# Beam Interlock System SPS CIBU Connection Review

Christophe Martin  
TE/MPE

## Presumed Failure

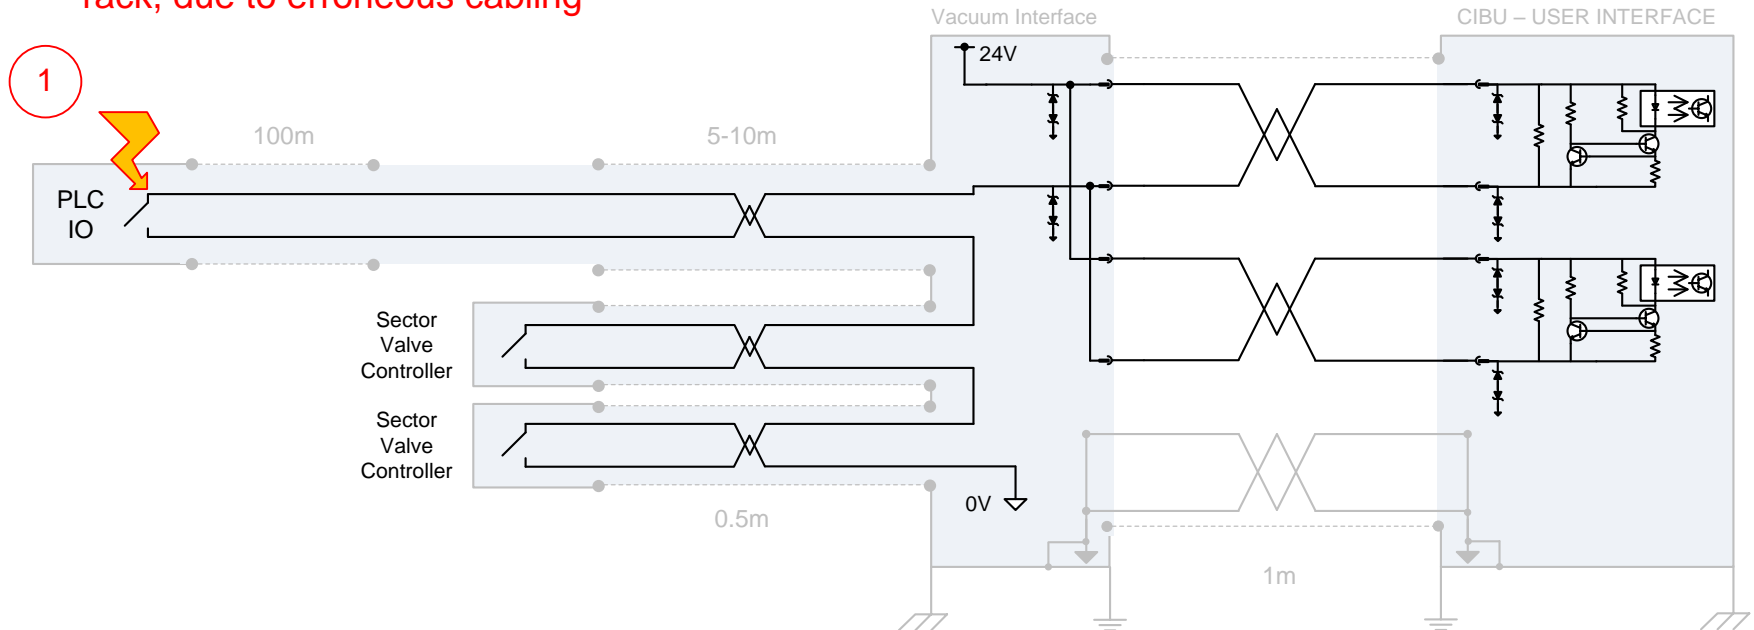
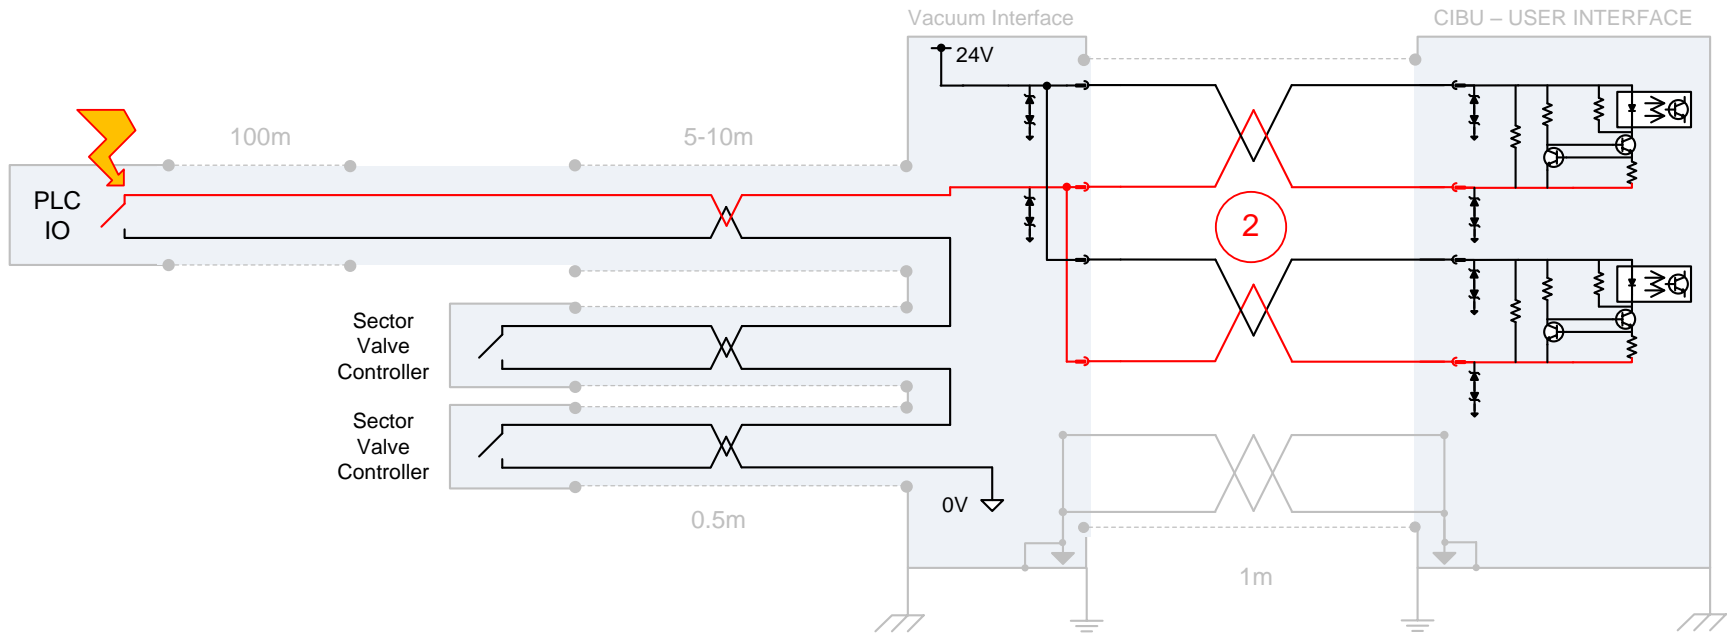
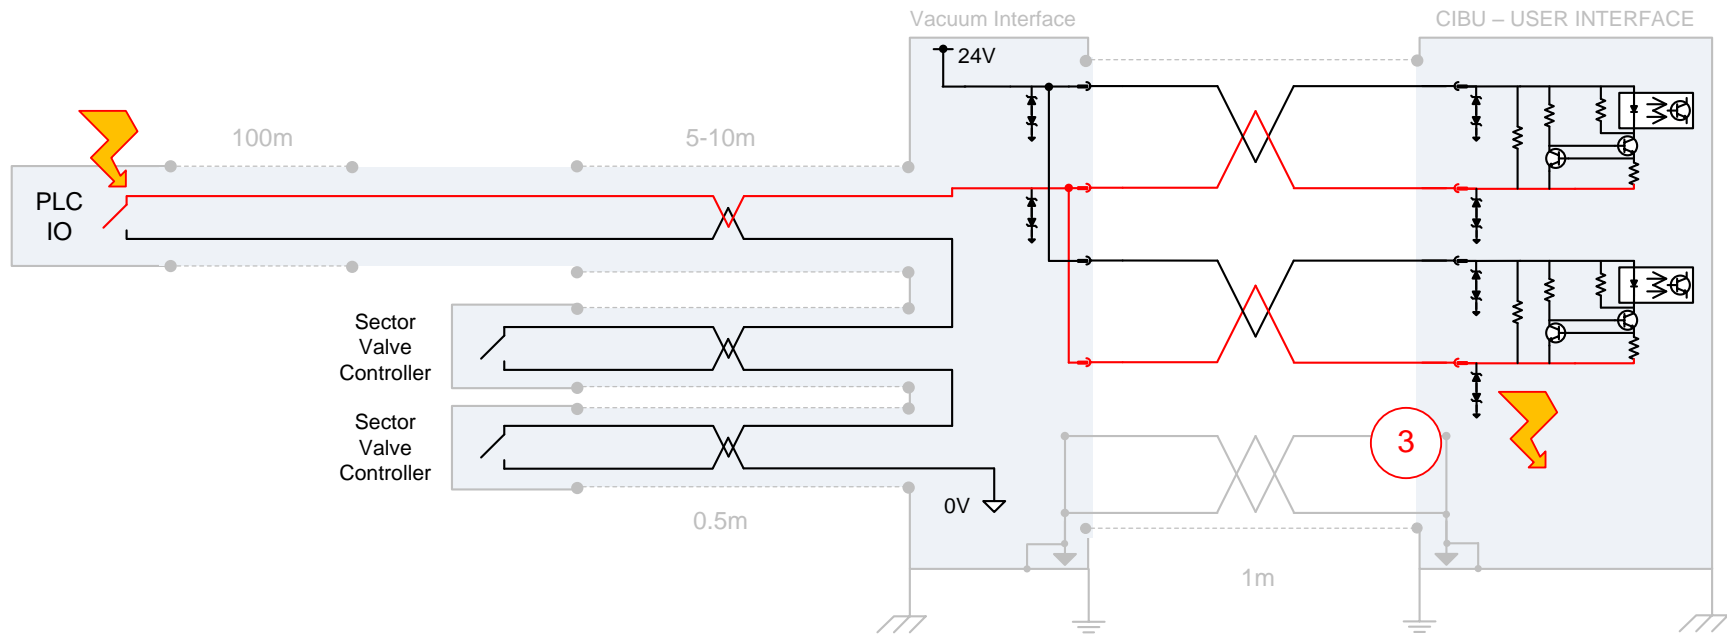
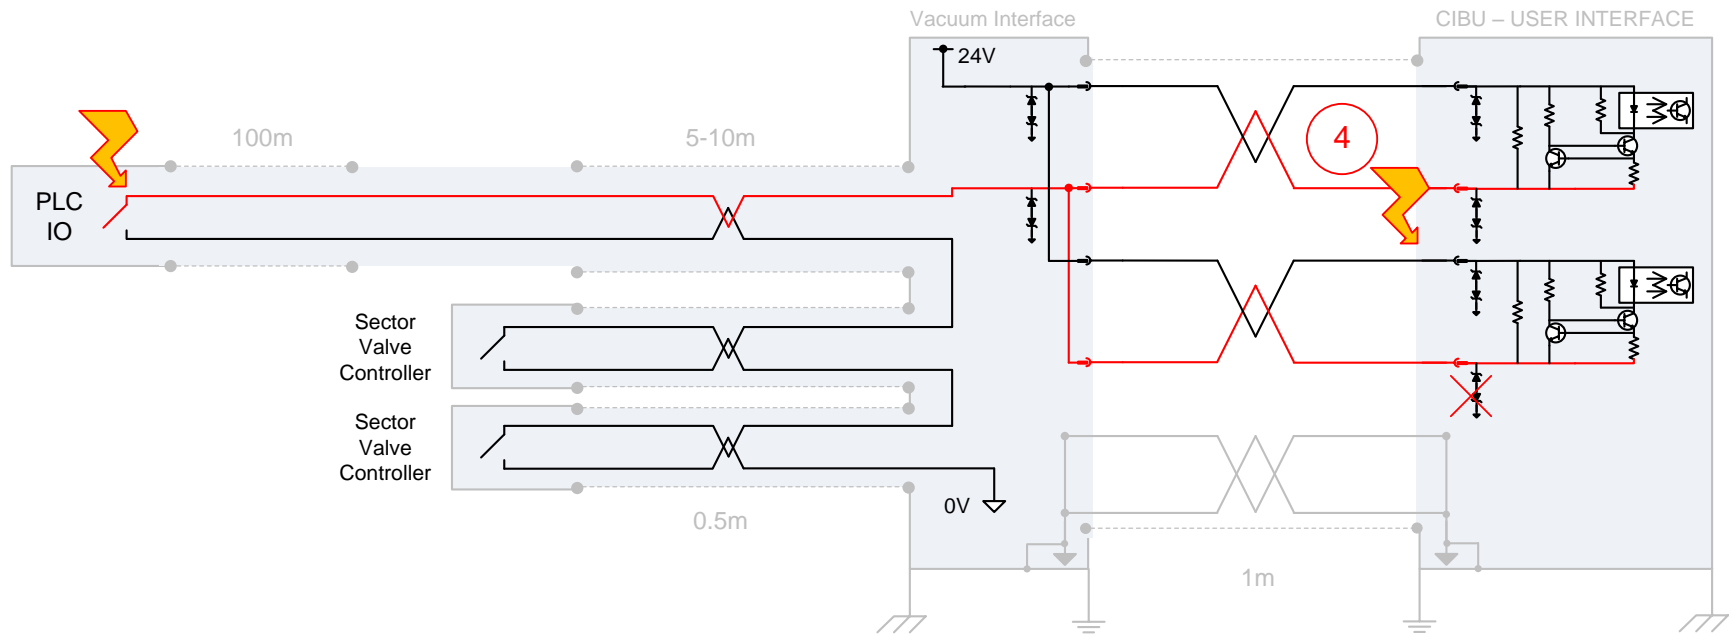
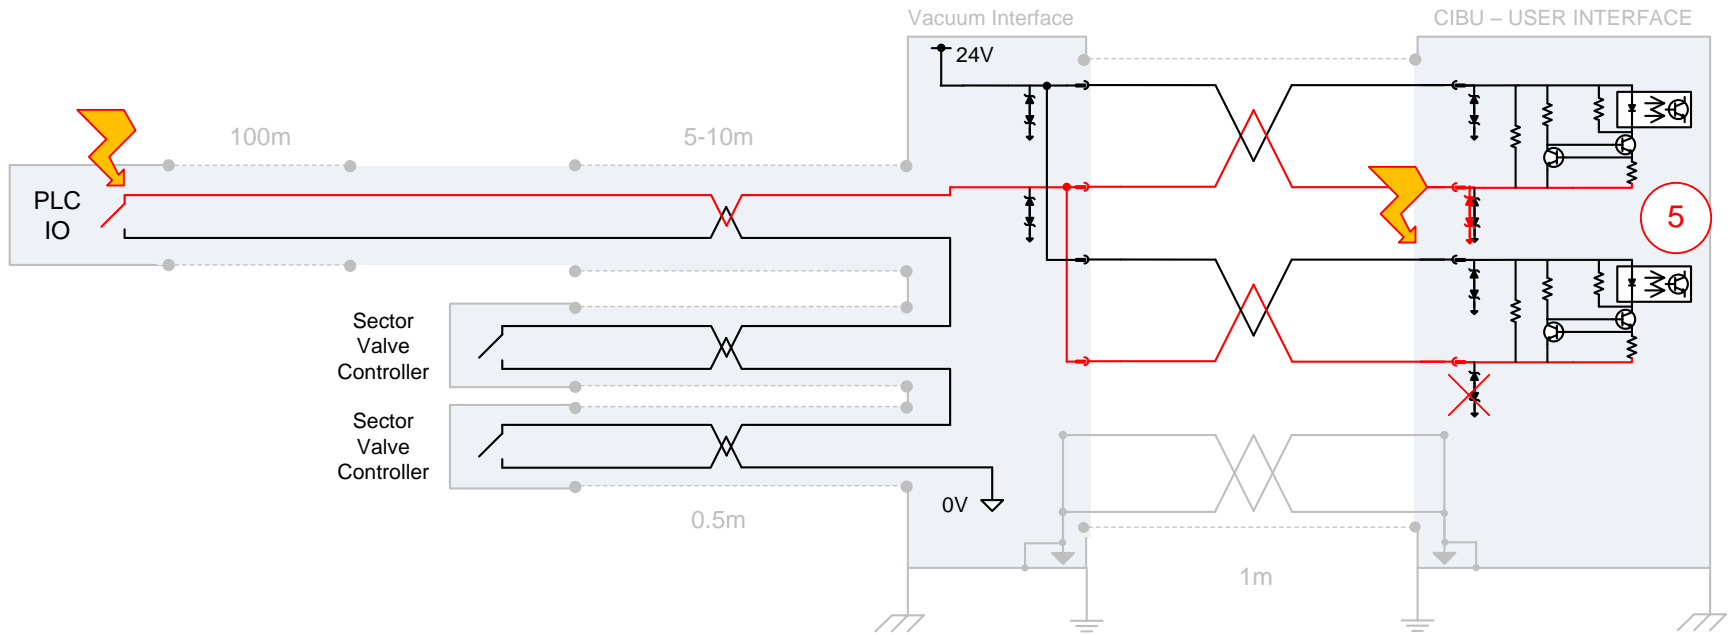
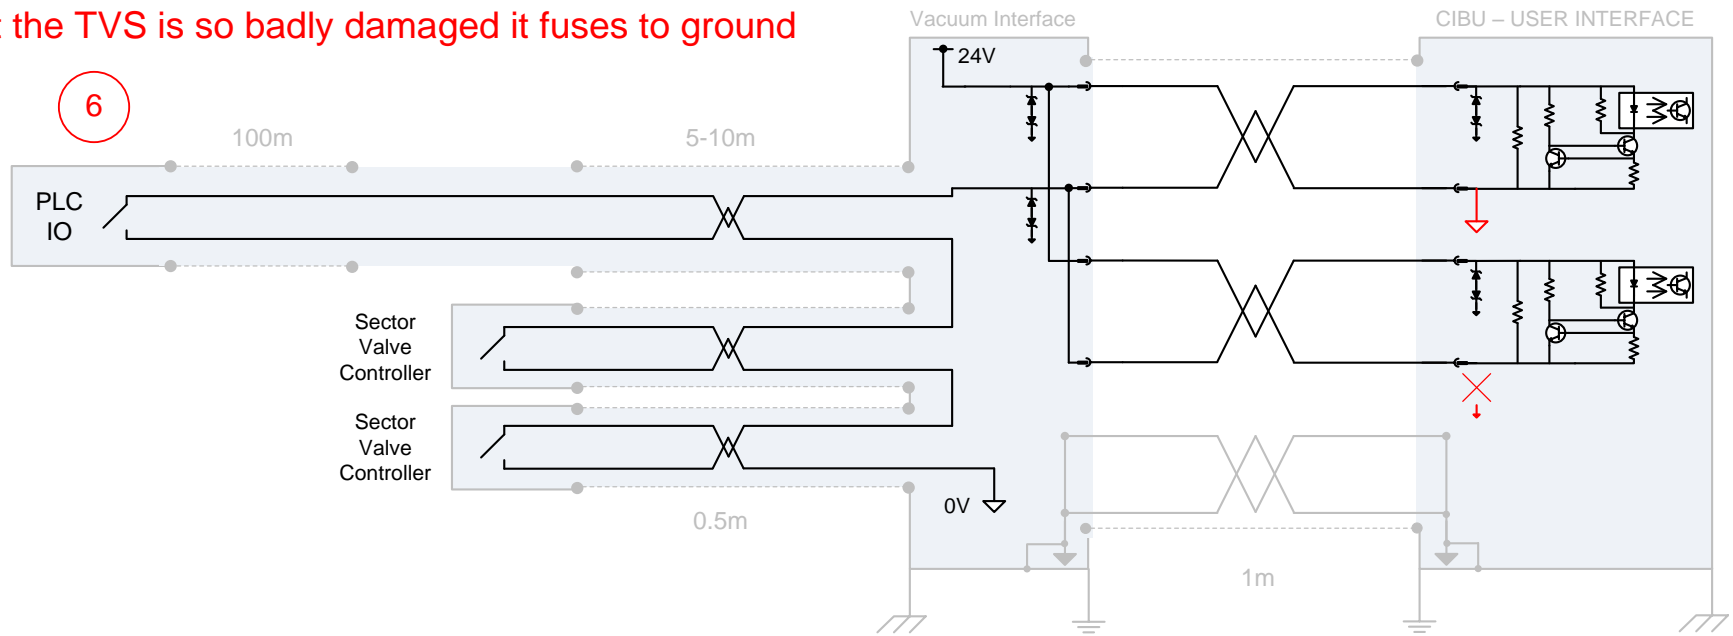
### 1. Excessive Voltage

Is applied in the Access System PLC rack, due to erroneous cabling

2. This subjects the CIBU negative current loop to an excessive voltage (48V)

3. The Transient Voltage Suppressor (SM6T30CA) Clamps the voltage and dissipates the energy

4. Experiments show that after 1-2 seconds the TVS will fail, this TVS fails open-circuit  
The 'A' loop TVS now absorbs the excess

5. 1-2 seconds later this TVS fails short-circuit
